## Application Review Summary

**For:** 515 Rithet  
**Meeting Date:** Tuesday, December 14, 2021  
**Application:** DPV 00187

**Re: 515/519 Rithet Street - Development Variance Permit Application – Revised Submission**

Reference: Rithet Building  
515 Rithet Street, Victoria, BC  
Development Permit Application DVP-00187 – 515 Rithet Street

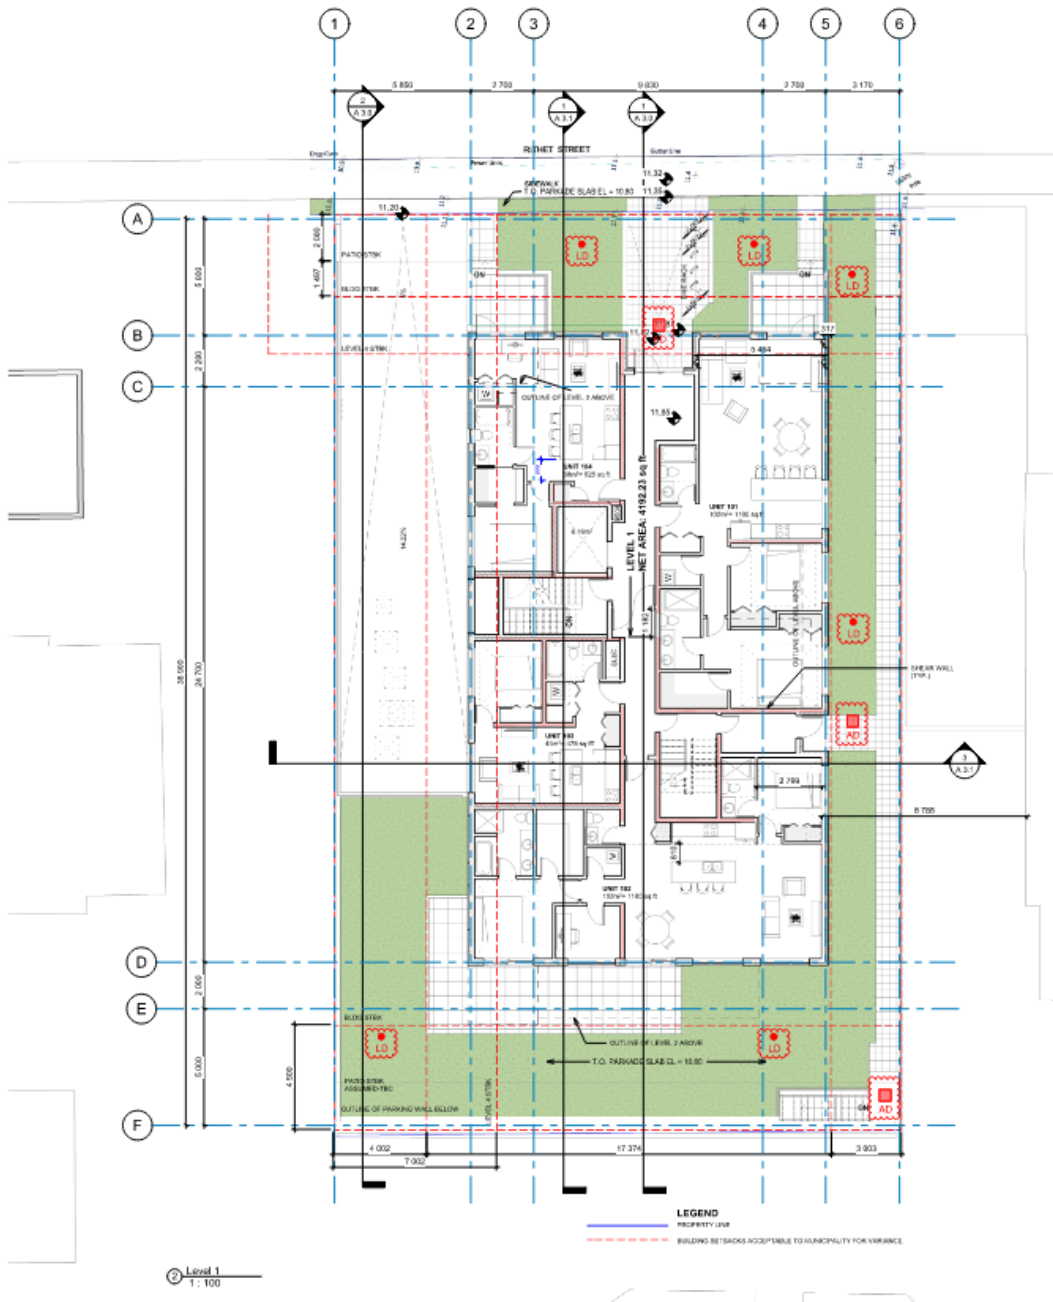
Comment ENG-UND-01.

Comment ENG-SWM-03.

1. The sewage calculation for the proposed new development at 515 Rithet Street was evaluated to have an expected flow rate of 216.5 FU.

1. The new development is expected to have a total of six buried landscape drains (LD) and three area drains (AD), as highlighted in the drawing below.

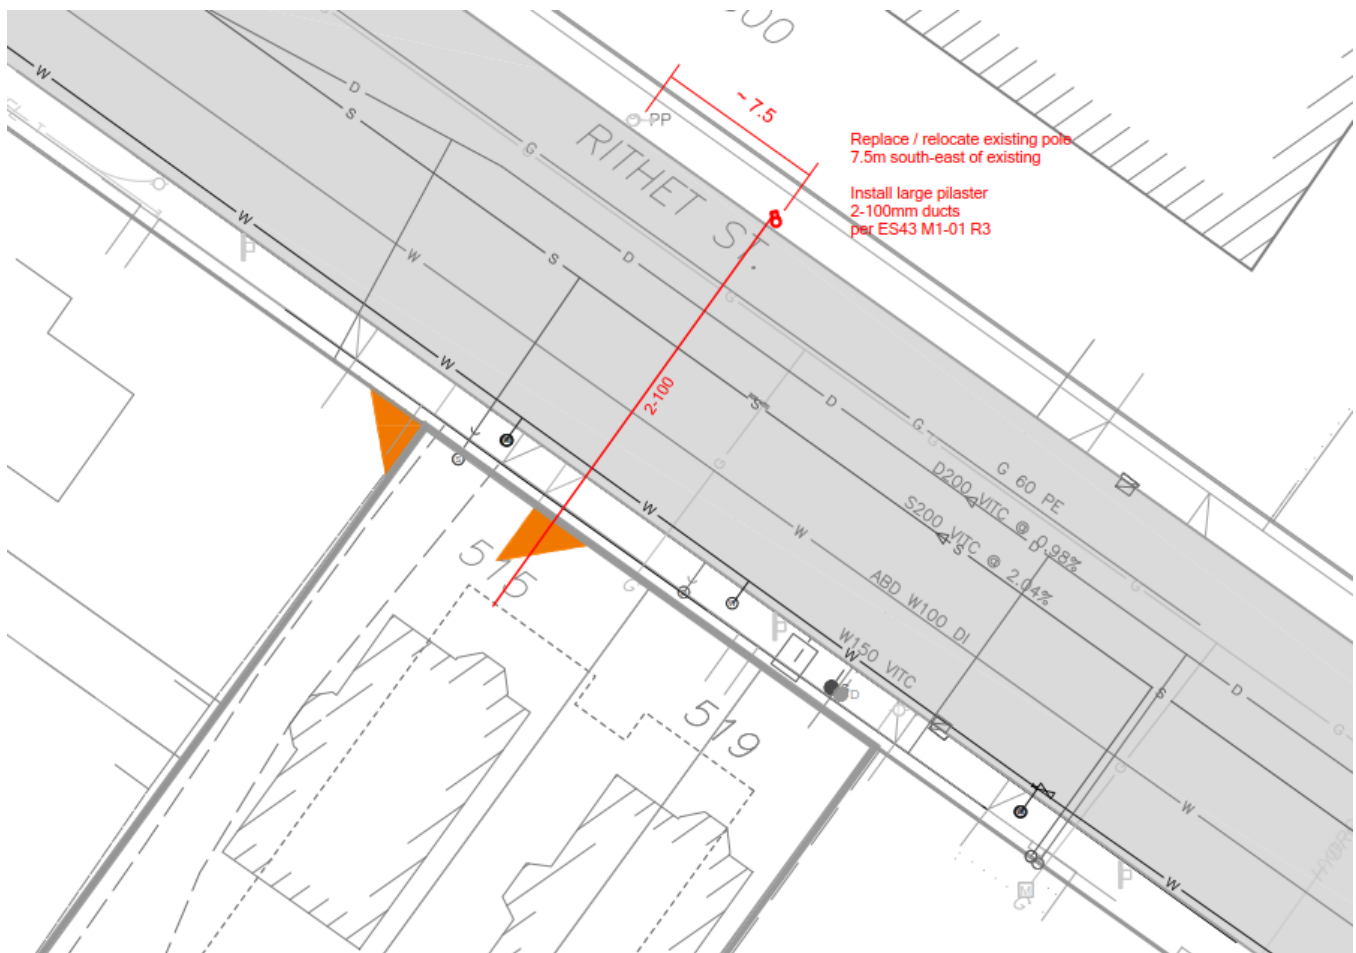
1. Land Development Review by Deb Becelaere, Sr. Engineering Technologist  
Comment ENG-LND-02

Comment ENG-LND-03

1. The electrical load calculation for the proposed new development at 515 Rithet Street was calculated to have a connected load of 175.15kW resulting in a service size of 800A-120/208V, 3Ph, 4W (80% rated). This service size does not warrant a Pad Mount Transformer (PMT) on private property.

1. Discussions with regards to servicing of the development have been had with BC Hydro Design Technician, Bobbi Bucic. The pole on the south side of Rithet Street is aged and in need of replacement. BC Hydro has proposed replace the existing pole and to align the new pole with the proposed electrical room location. The new pole location and proposed underground conduits are illustrated in the attached plan provided by the BC Hydro Design Technician.
